STAFF RECOMMENDATION

907 Waldkirch Avenue

Application: New Construction—Addition

Description of Project: Application is to construct a rear addition that extends two feet (2') taller than the historic house.

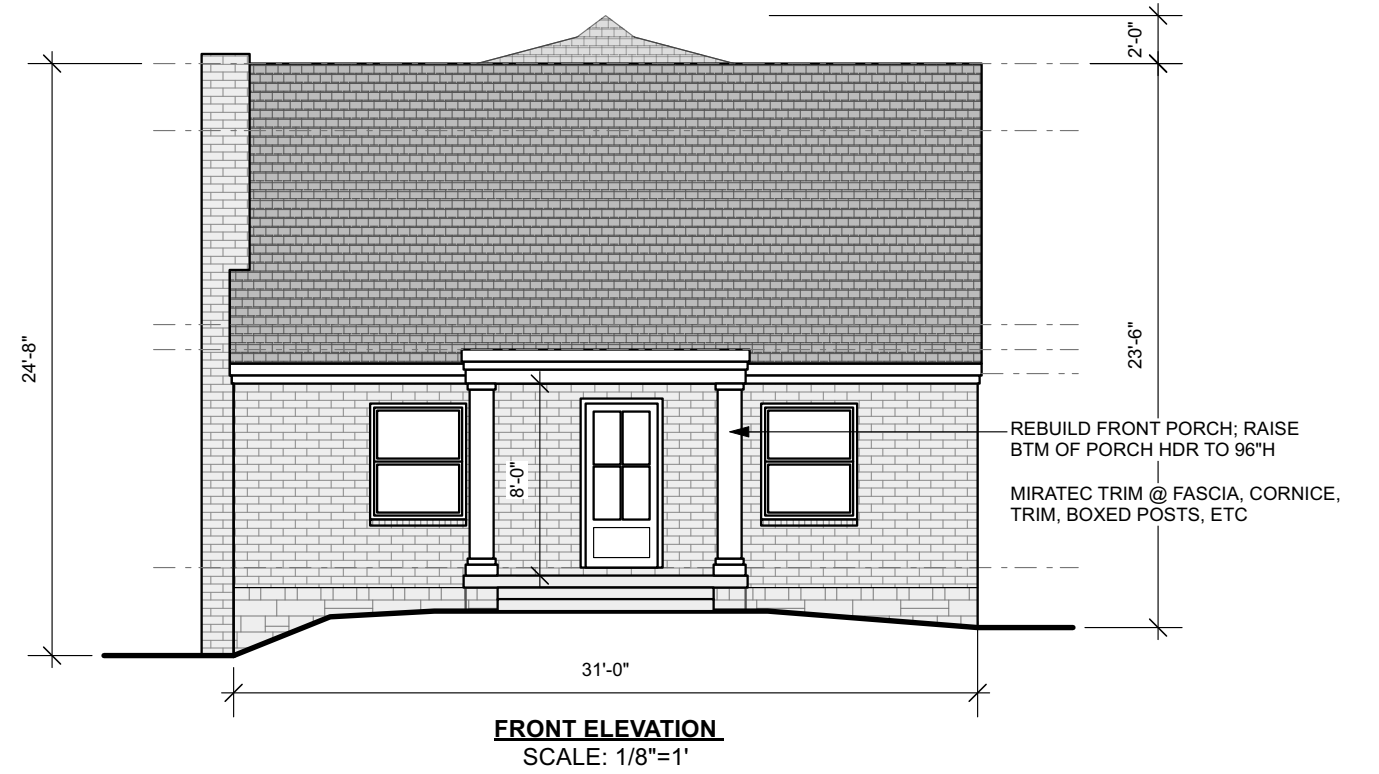
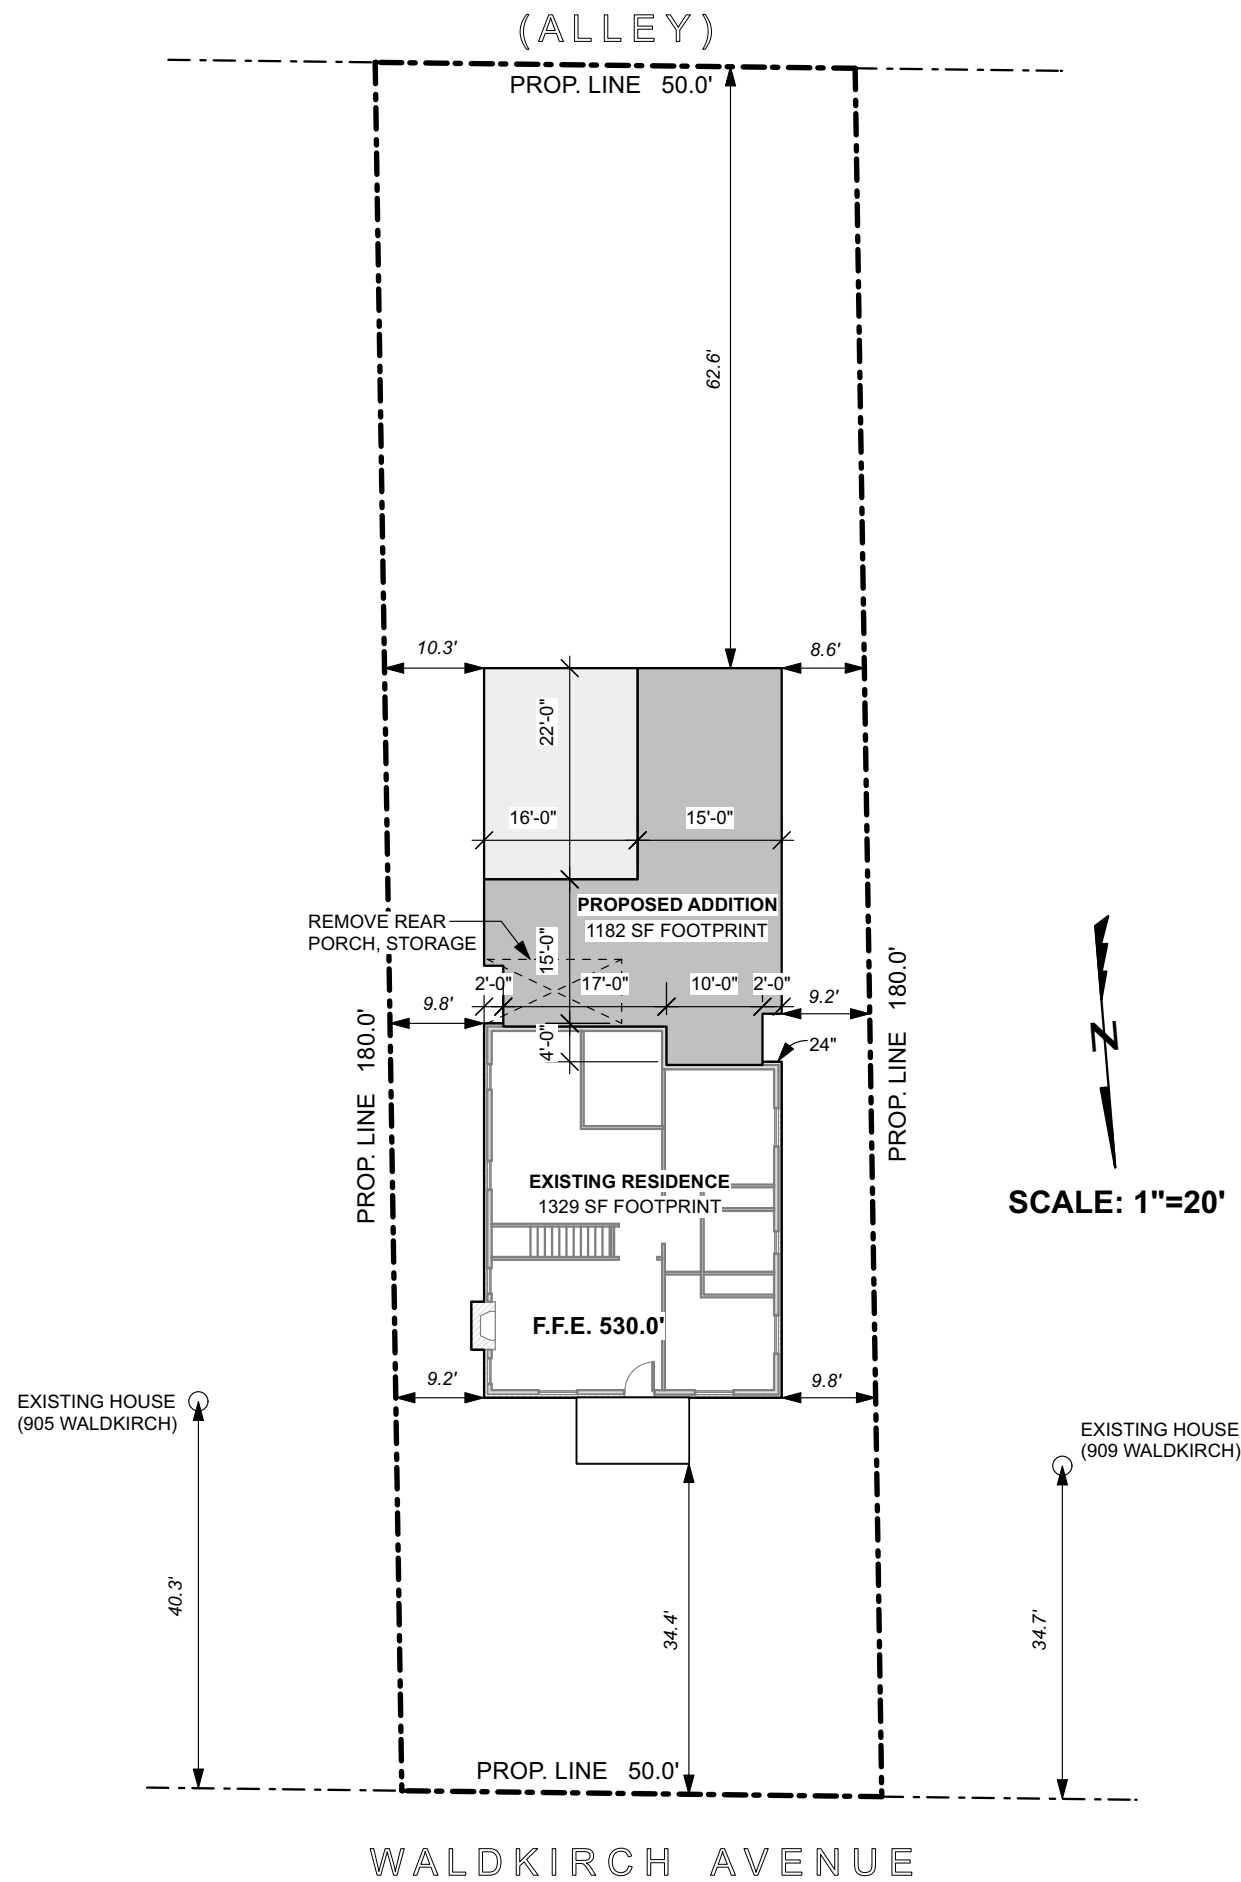
Proportion and Rhythm of Openings: No changes to the existing windows or doors were indicated on the plans. The windows on the proposed addition are all generally twice as tall as they are wide, thereby meeting the historic proportions of openings. Historically dormers are primarily glazing, and that has been a requirement in the past. Part of the lack of windows in the proposed side dormers is likely a result of the width of the dormers. However, staff recommends that the face of all side dormers should be primarily glazing.

With the condition that the side dormers primarily be glazing, staff finds the project's proportion and rhythm of openings to meet Sections III.G. and IV. of the design guidelines.

RIGHT SIDE ELEVATION
SCALE: 1/8"=1'

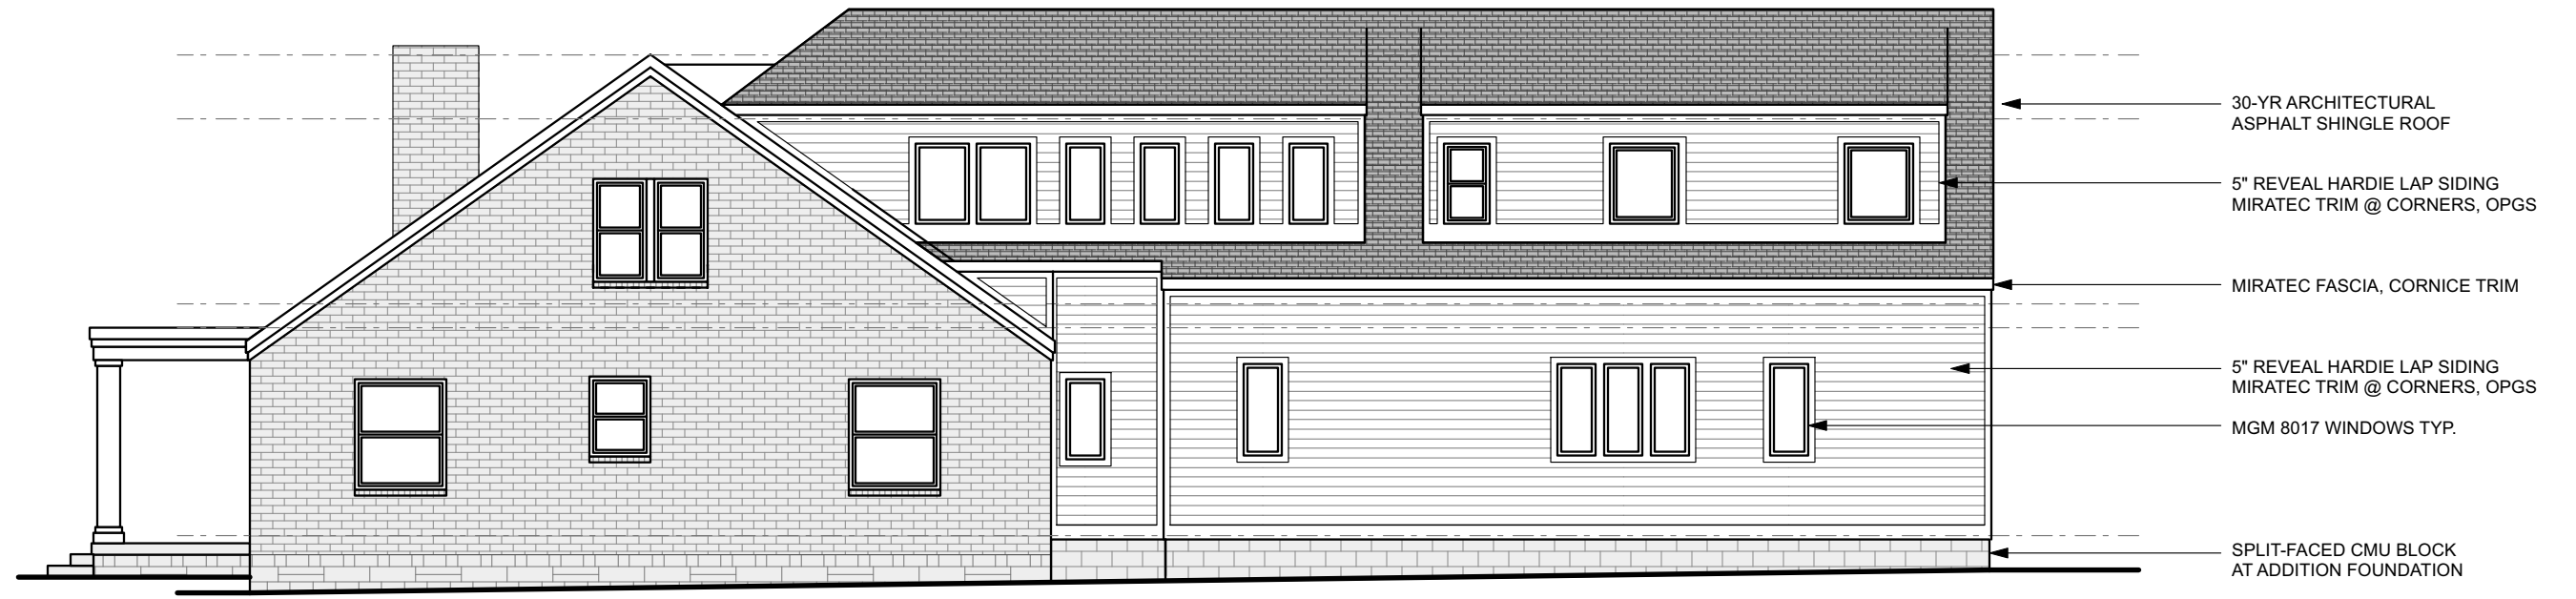
Height & Scale: The proposed addition is a two-story addition to a one-story house. The historic house reads as one-story from the front but has a steeply pitched roof that appears to accommodate some upper-level space. The proposed addition incorporates a pair of wide dormers on both side façades that, while broken up, create a two-story scale. The addition's foundation height is approximately six inches (6") taller than existing foundation, and the eaves are approximately three feet (3') taller than the historic house. Given the inset of the addition and location at the rear, staff finds that the foundation height can be appropriate. In order for the addition to be appropriately scaled to the historic house, staff recommends that the eaves more closely match those of the historic house and the width of the dormers be reduced.

The new construction also extends two feet (2') taller than the historic house approximately twenty-seven feet (27') beyond the front wall of the house while the design guidelines requires additional height to occur at least forty feet (40') beyond the front wall. Given the side-gabled roof form, a ridge raise is possible for this house. Staff, however, finds that the additional height as proposed may be appropriate in lieu of a ridge raise if the scale of the addition is appropriate for the house.

1. The eave height of the addition shall be similar to the eave height of the historic house;
2. The width of the side dormers shall be reduced;
3. Staff approve the final details, dimensions and materials of roof color, porch railing, and porch posts doors prior to purchase and installation;
4. The face of the side dormers shall be primarily glazing; and,
5. The HVAC shall be located behind the house or on either side, beyond the mid-point of the house, and utility meters shall be located on the side of the building, within 5' of the front corner. Alternative mechanical and utility locations must be approved prior to an administrative sign-off on building permit(s).
